IN THE DRAWINGS

REMARKS/ARGUMENTS

S03P0991

FIG. 2

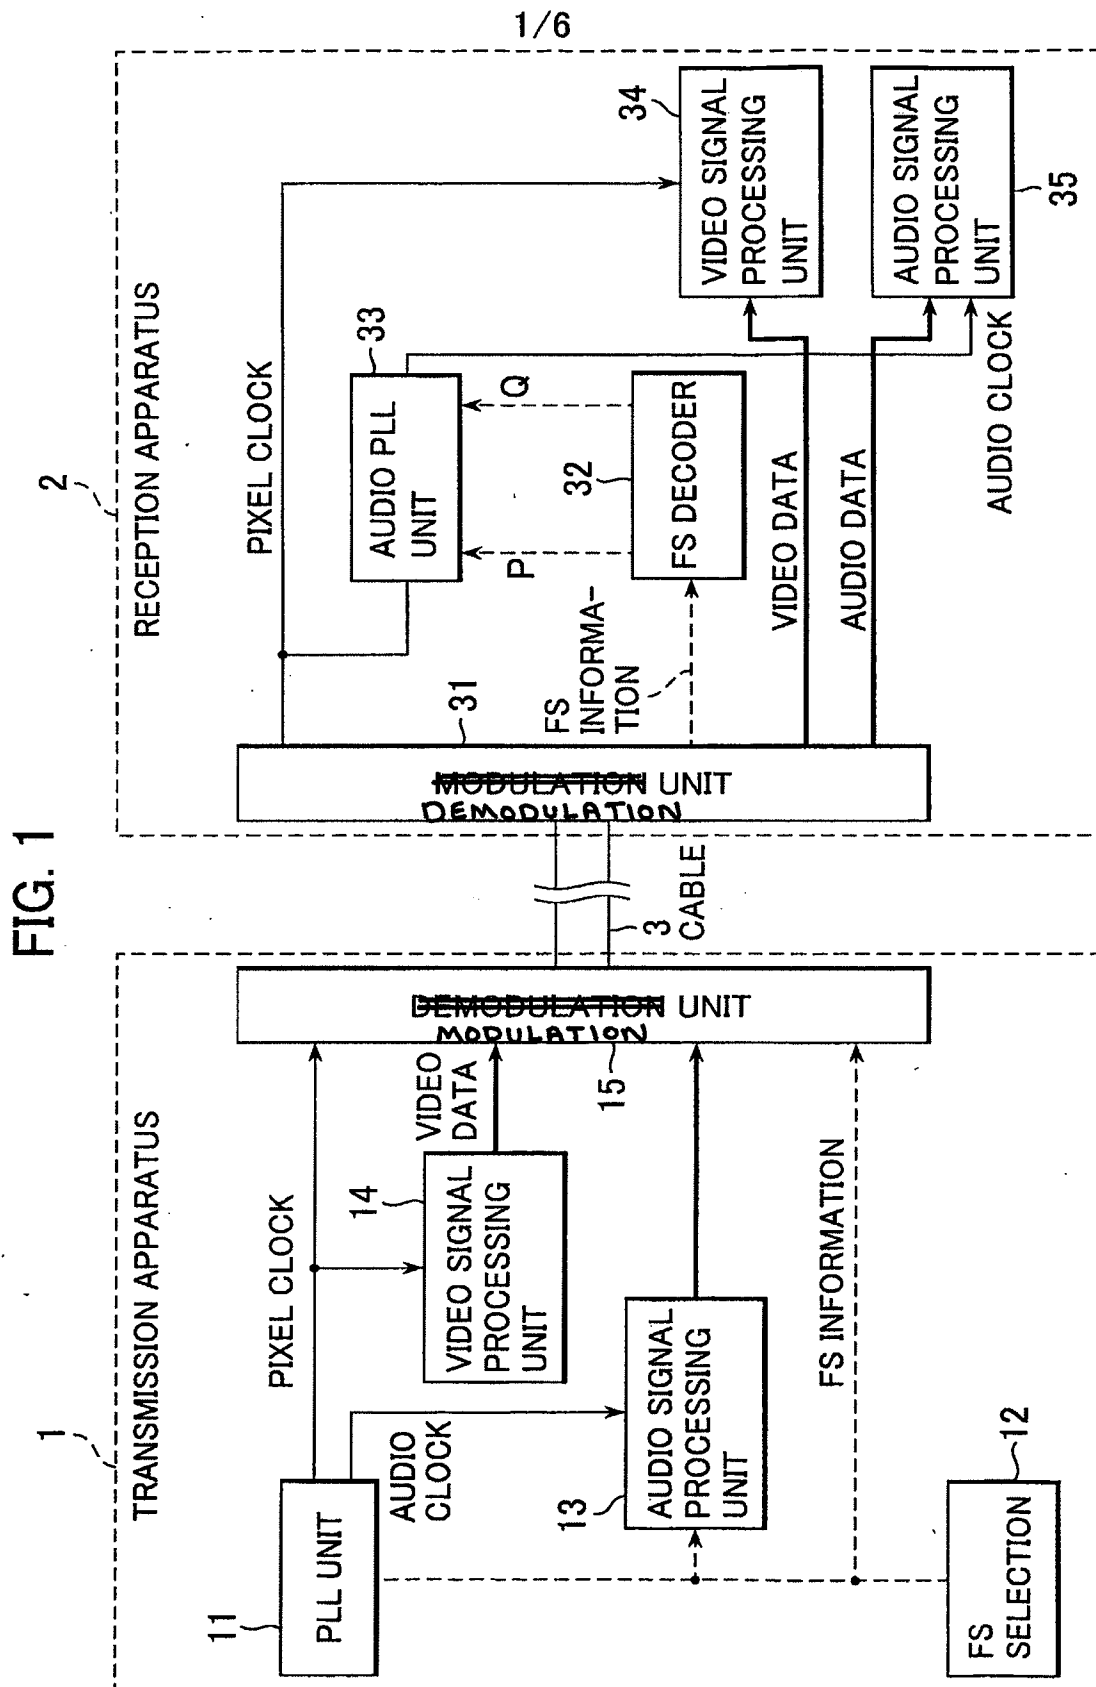
In Fig. 2, reference character “Q” has been replaced by reference character “P.”

Fig. 1 and Fig. 2 have been amended to address minor typographical errors. These corrections are fully supported by Applicant's disclosure. In Fig. 1, the text "DEMODULATION UNIT" associated with element (15) of the transmission apparatus (1) has been replaced by "MODULATION UNIT." Conversely, the text "MODULATION UNIT" associated with element (31) of the reception apparatus (2) has been replaced by "DEMODULATION UNIT." These amendment are supported by paragraphs [0023]-[0024] of Applicant's disclosure. In Fig. 2, the text "DIVISION RATIO Q" associated with the broken line connecting the Fs decoder (32) to the variable divider (55) has been replaced by "DIVISION RATIO P." This amendment is supported by paragraph [0042] of Applicant's disclosure.
